# SERVICE LETTER

No. 866

Piper Aircraft Corporation

Subject: Windshield Wiper Arm Retaining  
Wire Installation

Typical Windshield Wiper Blade

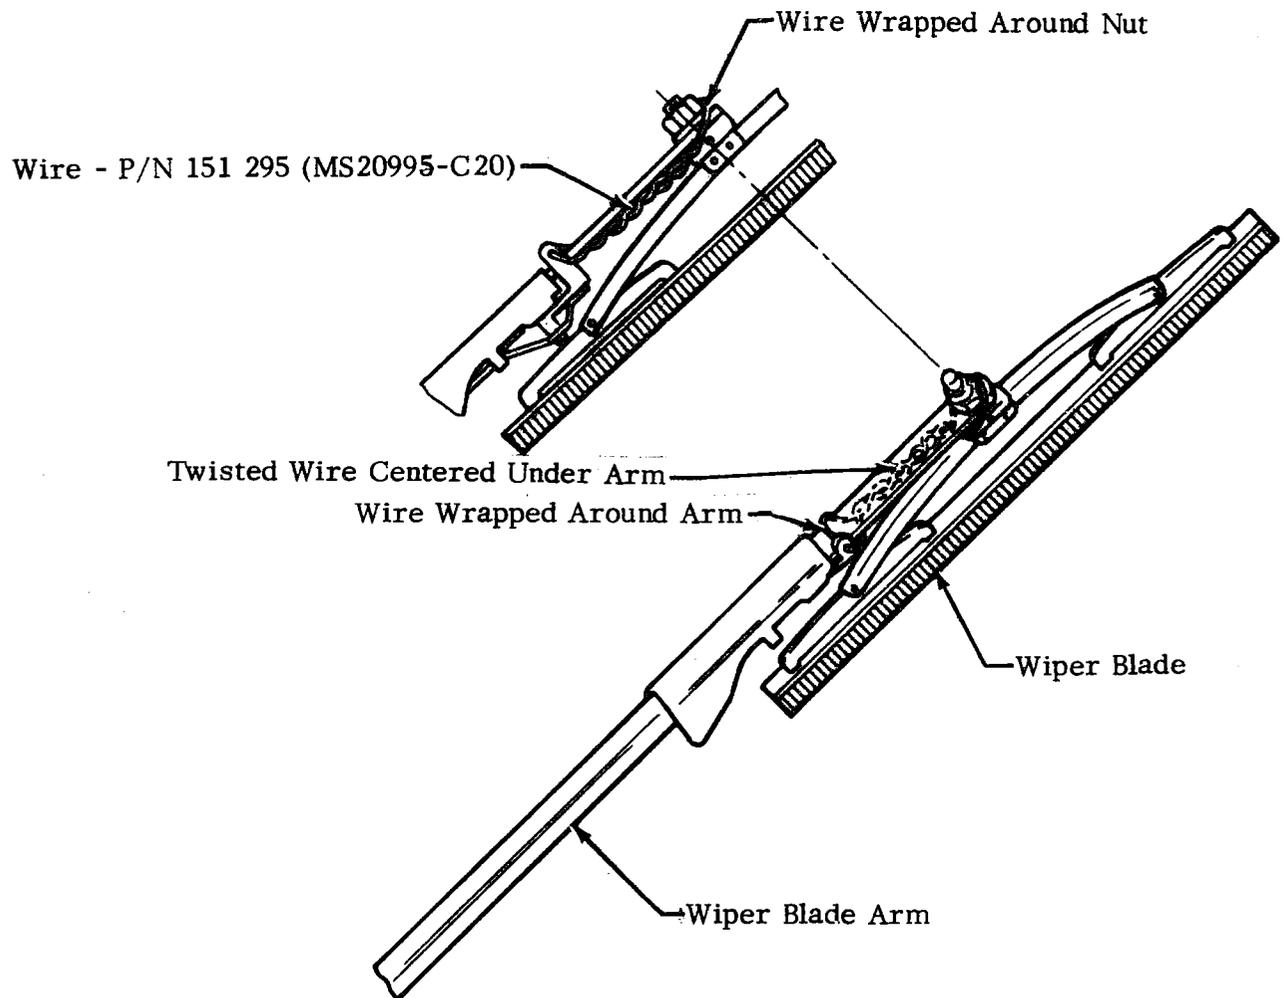
Several reports have been received of windshield wiper arms separating during wiper operation. Such separation could result in the scratching of the windshield by the wiper arm.

This service release provides instructions for the installation of a retaining wire to protect against separation of the windshield wiper arms.

Refer to sketch. Install MS20995-C20 wire as shown to safety the two sections of the wiper arm. Make appropriate logbook entry of compliance with this service release.

MS20995-C20 Wire (Piper Part Number 151 295).
